30% DESIGN SUBMITTAL - NOT FOR CONSTRUCTION

MERCER ISLAND LUTHER BURBANK DOCK REPAIR

COMPOSITE SITE PLAN

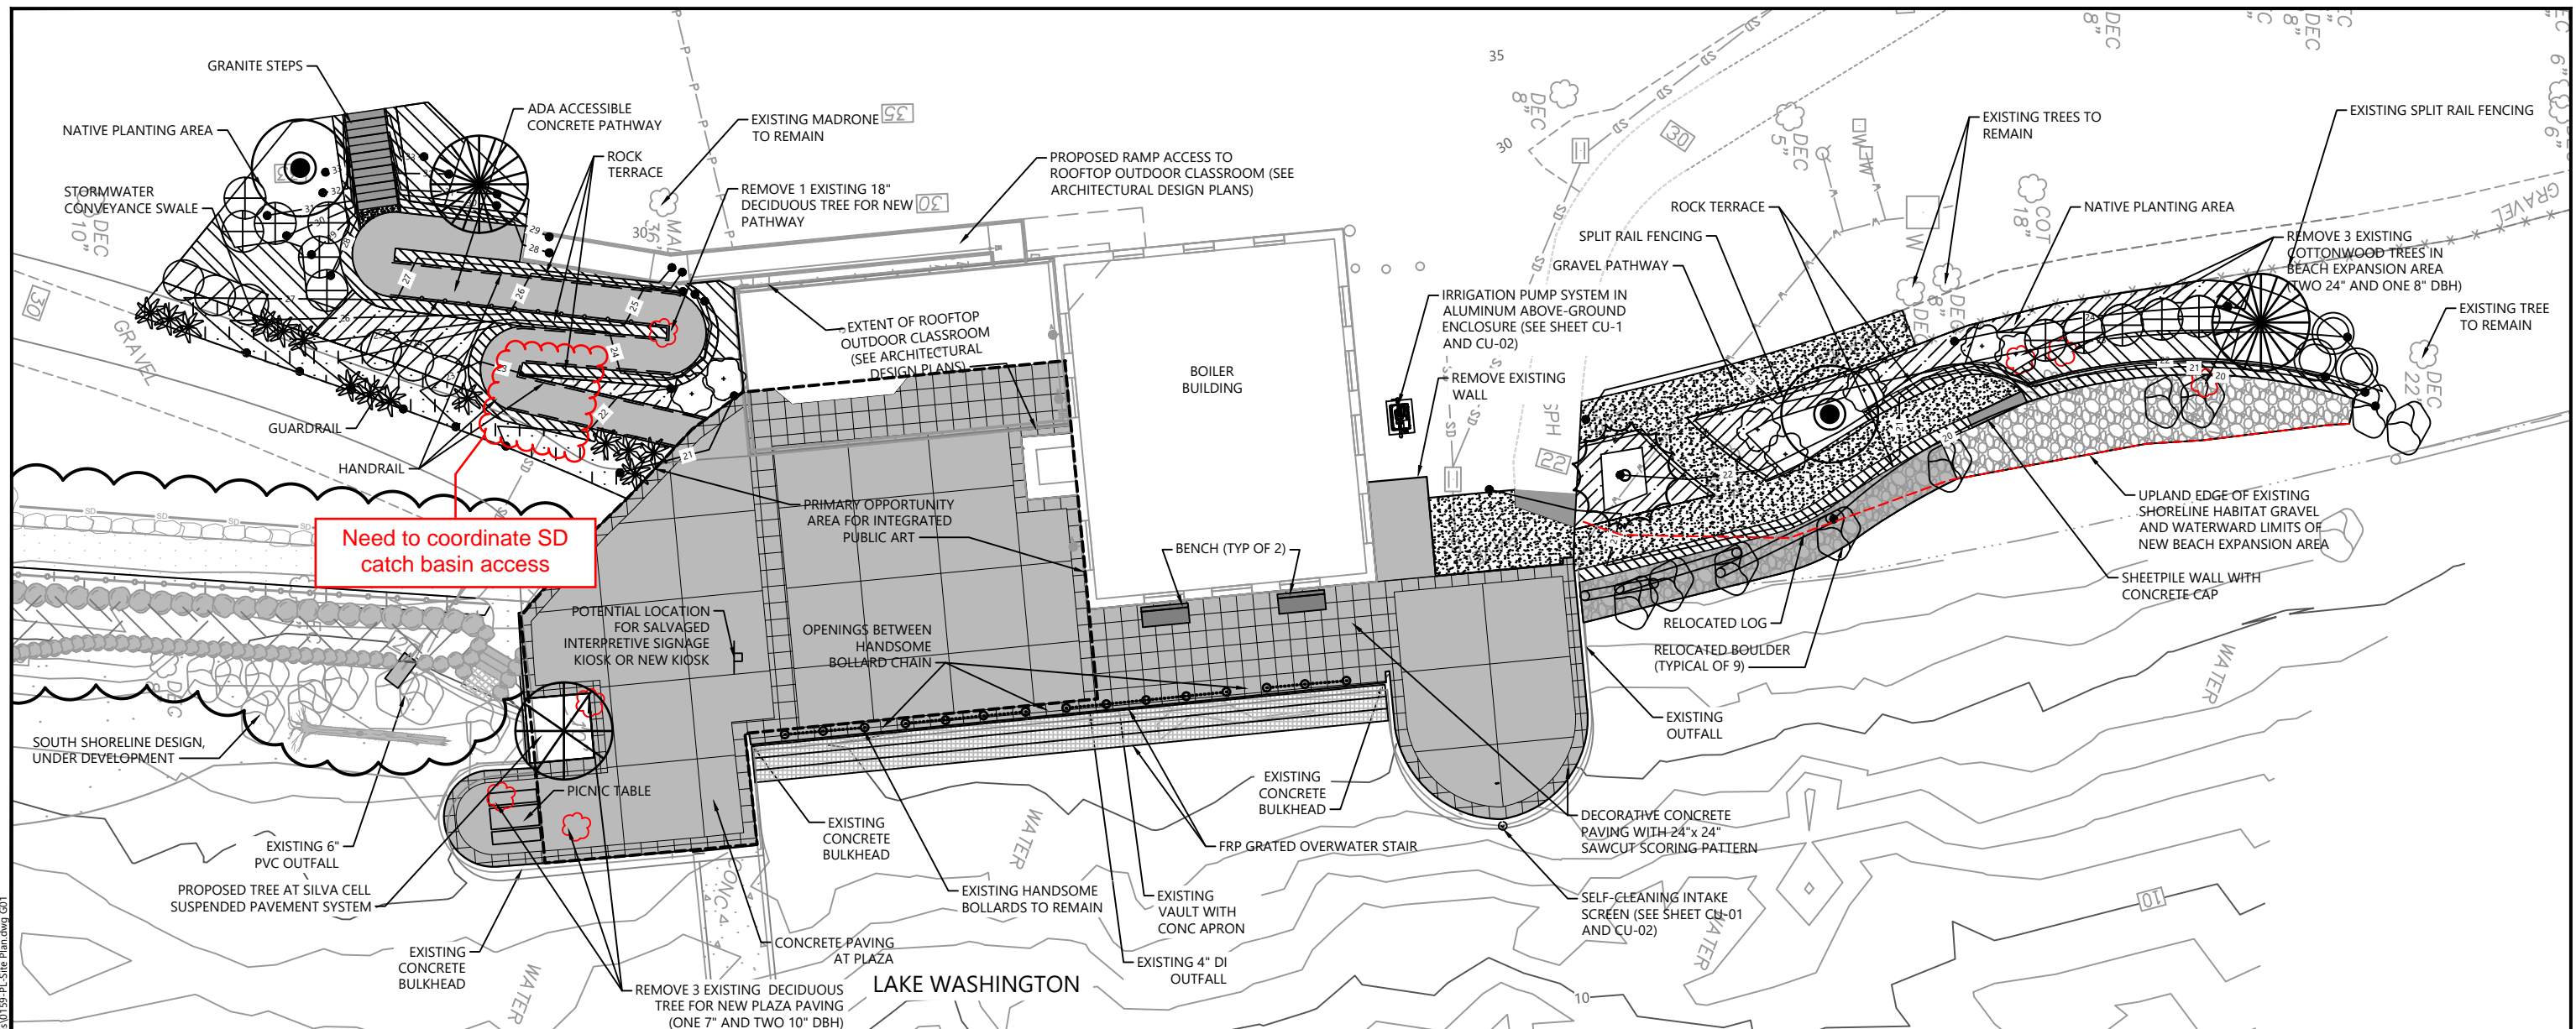
Need to coordinate SD catch basin access
